15094 Community bank Headquarters – Precast review

Based on the following documentation received over the course of the precast remediation period, Dale Partners Architects approves the work based on the following:

COMMUNITY BANK HDQTRS.
 FLOWOOD, MISSISSIPPI

FIELD MODIFICATION

DETAIL (21)

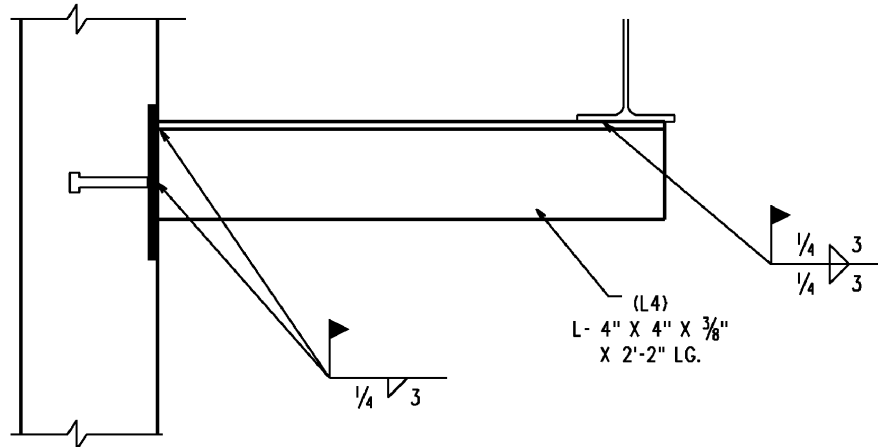
DESCRIPTION OF PROBLEM

NOT WELDED PER DETAIL
WELDED SOLID @ PANEL W/OUT
BOLTED SLIP PLATE

DETAIL (16)

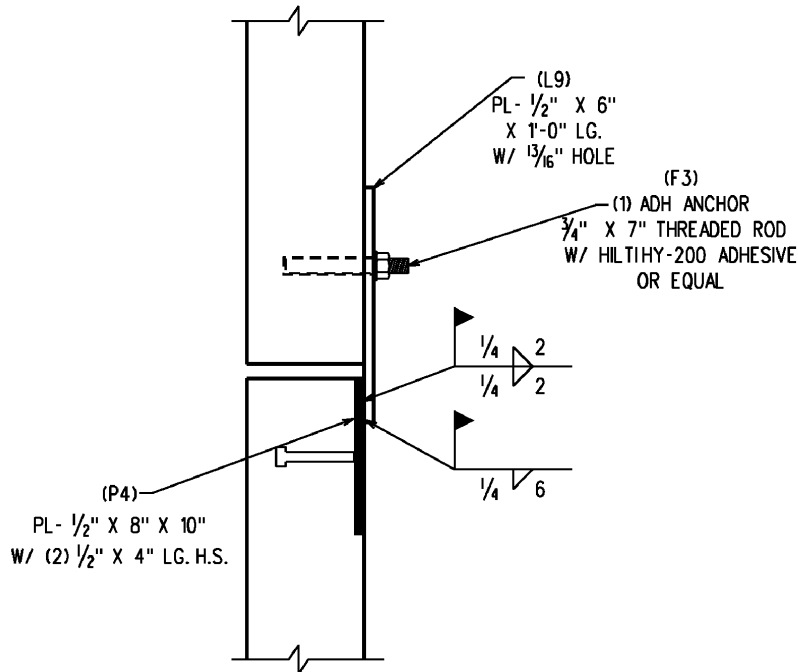
DESCRIPTION OF PROBLEM

PSA INSERT MISSING FROM PANEL

REF: **10**
 FM. NO.: **10-14**

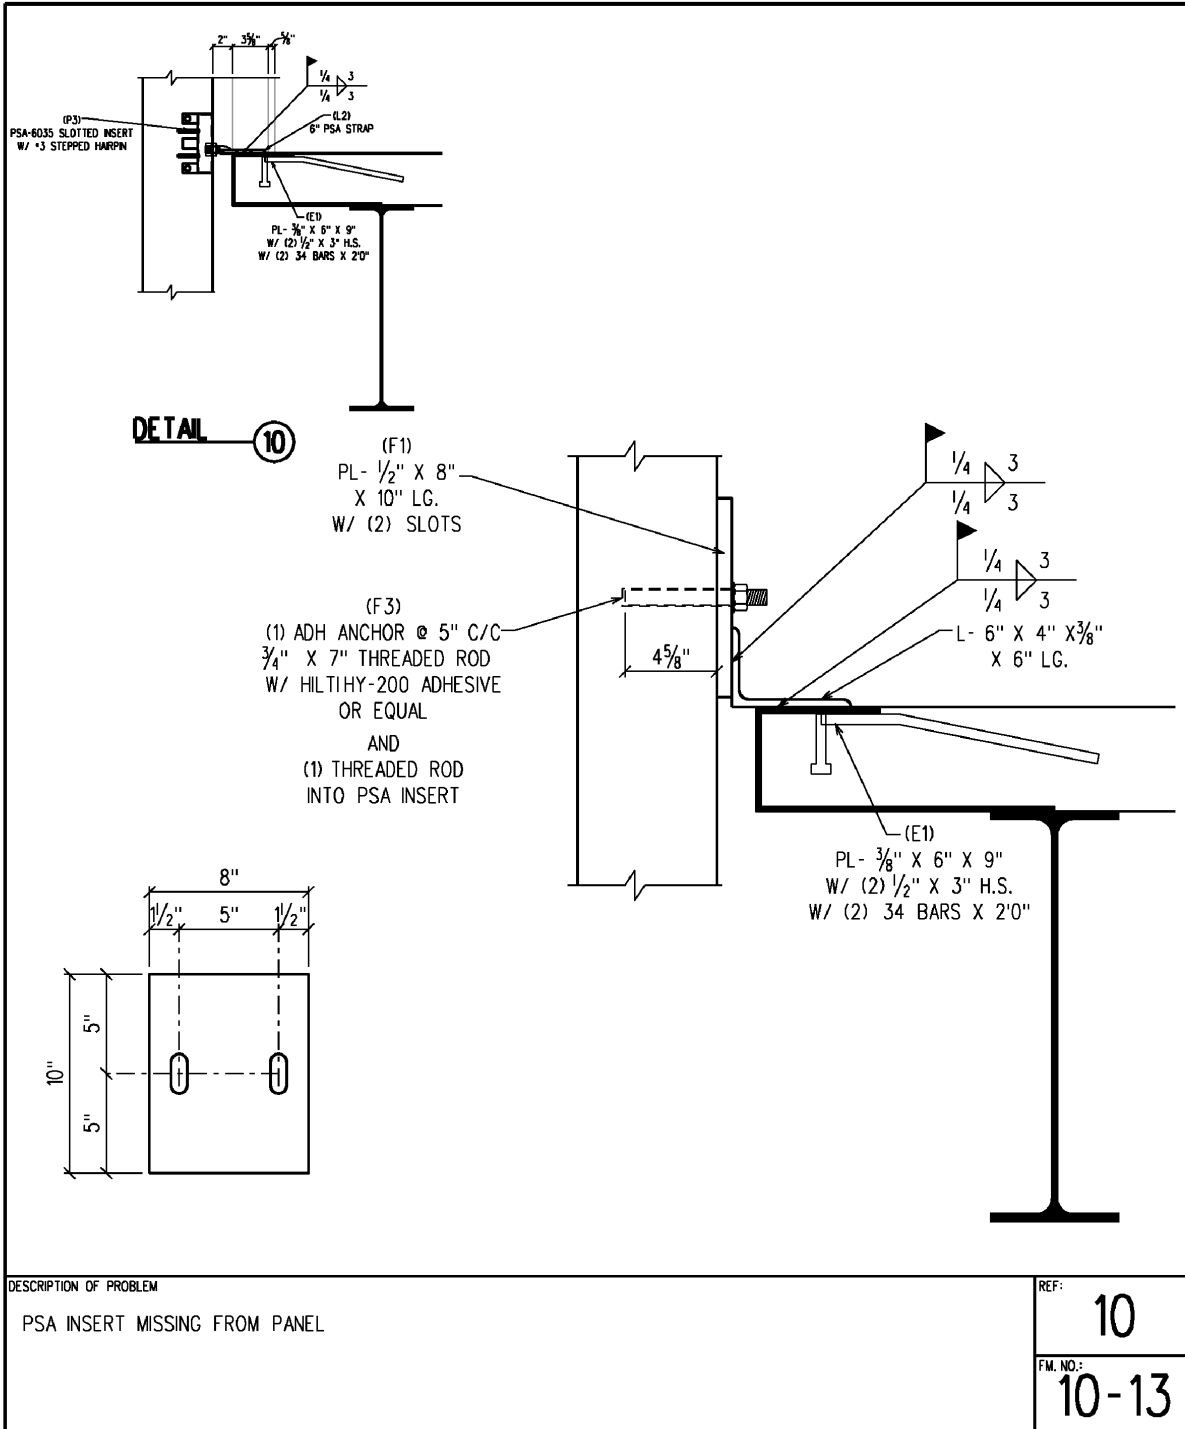
DESCRIPTION OF PROBLEM
 SLAB CUT OFF 3" CUTTING H.S. FROM EMBED

DETAIL 09

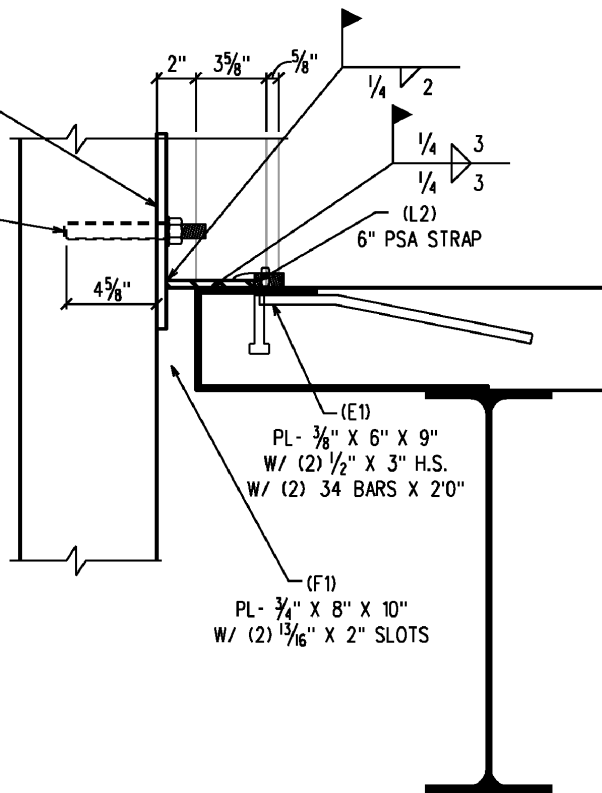
DESCRIPTION OF PROBLEM

PL - 1/2" X 8" X 10" LG. W/ (2) SLOTS

(F3) (2) ADH ANCHOR @ 5" C/C 3/4" X 7" THREADED ROD W/ HILTIHY-200 ADHESIVE OR EQUAL

DETAIL 02

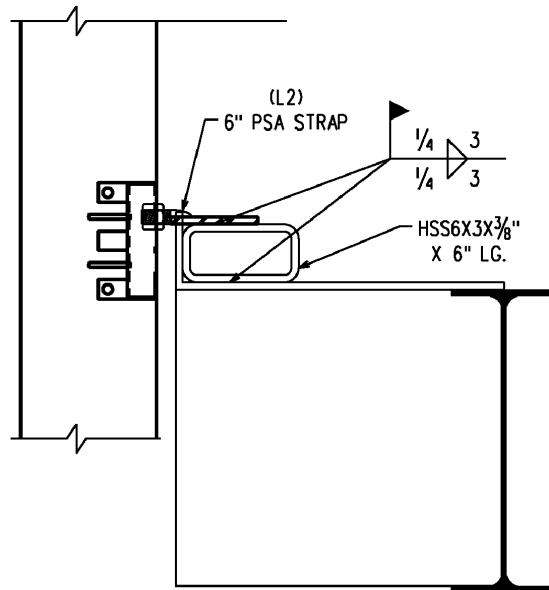
DESCRIPTION OF PROBLEM

HSS SPACER ADDED

DETAIL 02

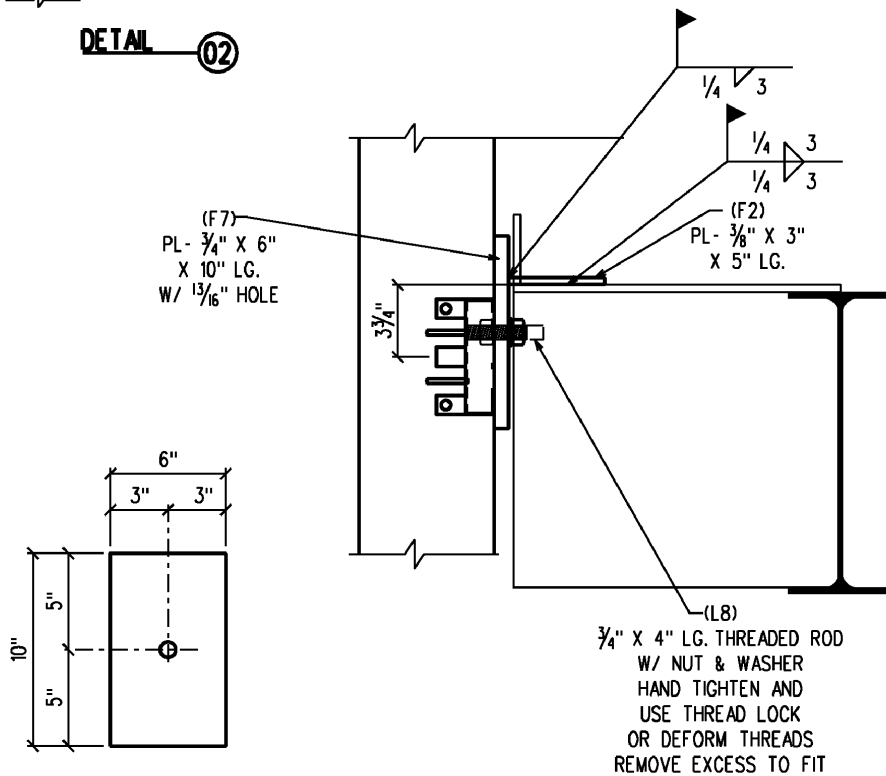
DESCRIPTION OF PROBLEM

(L8)
 $\frac{3}{4}$ " X 4" LG. THREADED ROD
W/ NUT & WASHER
HAND TIGHTEN AND
USE THREAD LOCK
OR DEFORM THREADS
REMOVE EXCESS TO FIT

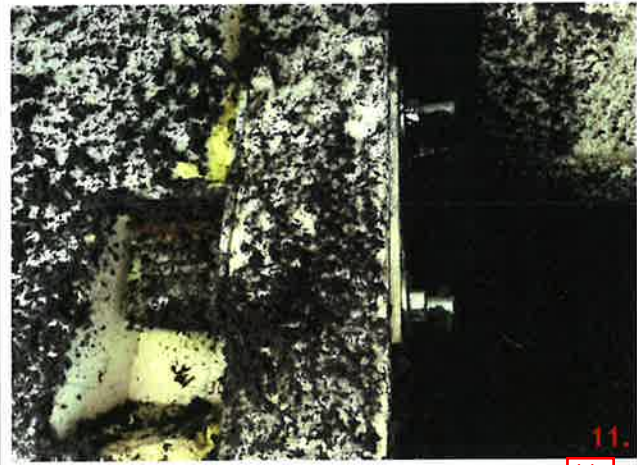
Panel 108 at grid line C has two connection points detailed 10 that have been modified using FM 10-5. These connections meet the requirements of this FM.

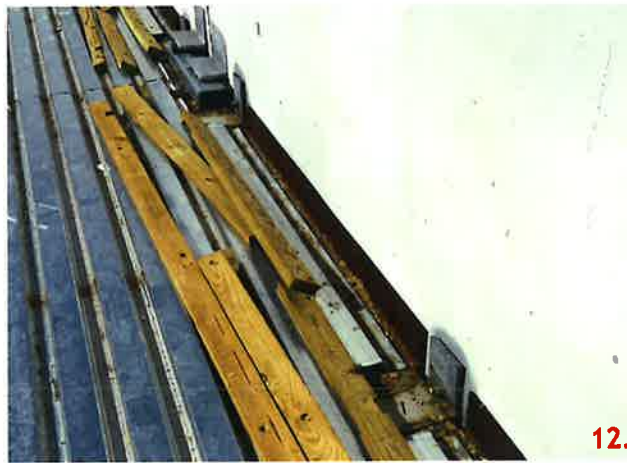
Panel 122-1, at connection point 22 the embedded angle was installed too high but not 4" high. The bottom leg of the angle was cut off and a new L6x6 angle with gussets was welded to the embedded angle all around. A field modification was not provided for this connection.

Panels 123-2, 124-2, 125-1 and 126-1 have modifications at the 07 and 02 connections. It does not appear that these connections needed a modification as the threaded rod is screwed into the PSA clip at an elevation that would have permitted the 3/4" diameter smooth rod and 6" PSA strap to be welded to the perimeter angle.

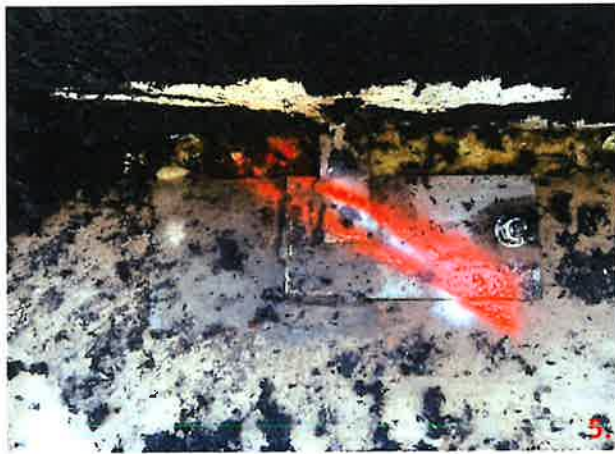
An example of connection points detailed 10 that have been field modified on panel 109B and 109A.

Panel 118-2 connection point detailed 18 has been field modified. The HSS6x3x3/8 has been welded to a plate 3/8x4x11.5. The plate is welded to the embed plate of panel 117-1 with a 1/4" fillet weld 4" length on three sides. The 3/8x4x11.5 plate is bolted through panel 117-1 with two 3/4 threaded rods with a 3x4x3/8 plate backer along with washers and nuts.

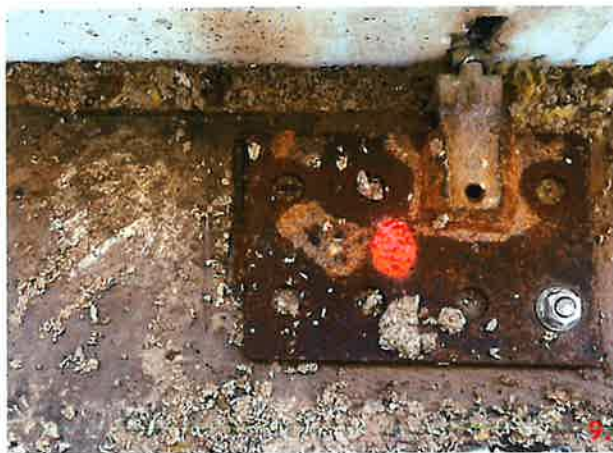
Panel 109-13 and 109-10 have two connection points detailed 10 that have been field modified. The PSA strap is welded to a plate 1/2x7x10 that is welded to the embed on one side and anchored to the slab on the other side. FM 10.4 and FM 10.3 could have been used for these connections.

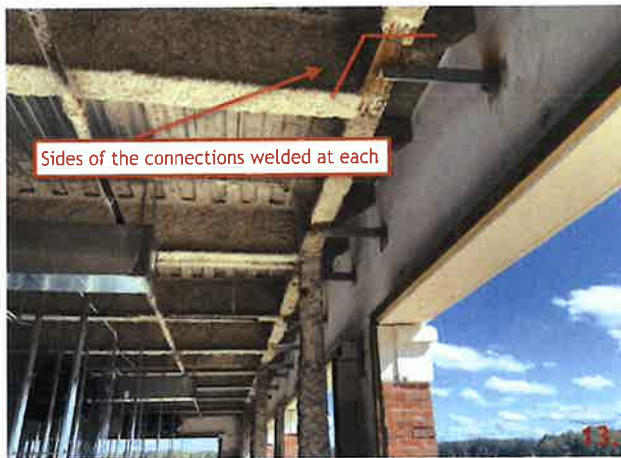
L4x4x3/8 angels at elevation 49'-4" are welded with 6" of 1/4" fillet weld to the beam but not in the detailed locations.

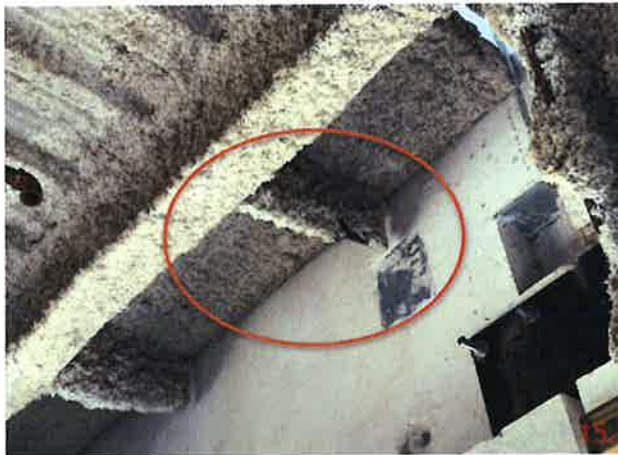
The P7 plate is missing from panel 228 at grid line 3 at elevation 49'-4". Field modification FM18-7 was used at this location. The welds of the connection are on the vertical leg of the 3/4x8"x1'-4" plate and do not have a 1" return.

One L4x4x3/8 angles is not installed on panel 229 at grid line 2 at elevation 49'-4".
